Report on Pause Sub-group Zoom meeting with the Consultants

2nd Sep 2021

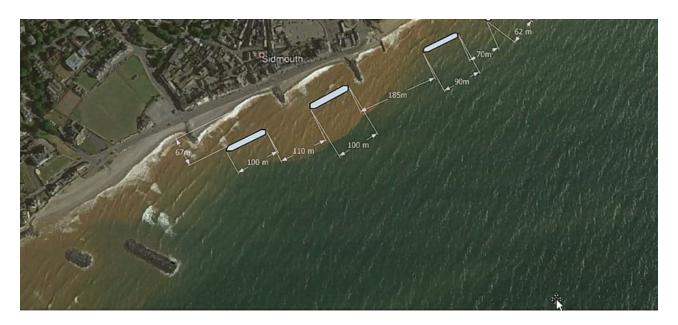
If we were to 'almost revert' to the preferred option + a proper foundation to allow the splash wall to be increased in height over time + an island off town beach; then we would only need to find out how much extra money we would have from the increased Government funding to allow us to work out how big the island could be. An image for this was presented later.

The difficulty would be in working out how to present the change from relying on a splash wall for defence to using an island instead, in order to make sure we would actually qualify for the extra money available.

However, the consultants don't know if this is an affordable option; because they don't know how big the island could be and how many years it would provide protection before we needed the splash wall to be raised. Looking a long way into the future is is likely that a wall will be needed at some stage.
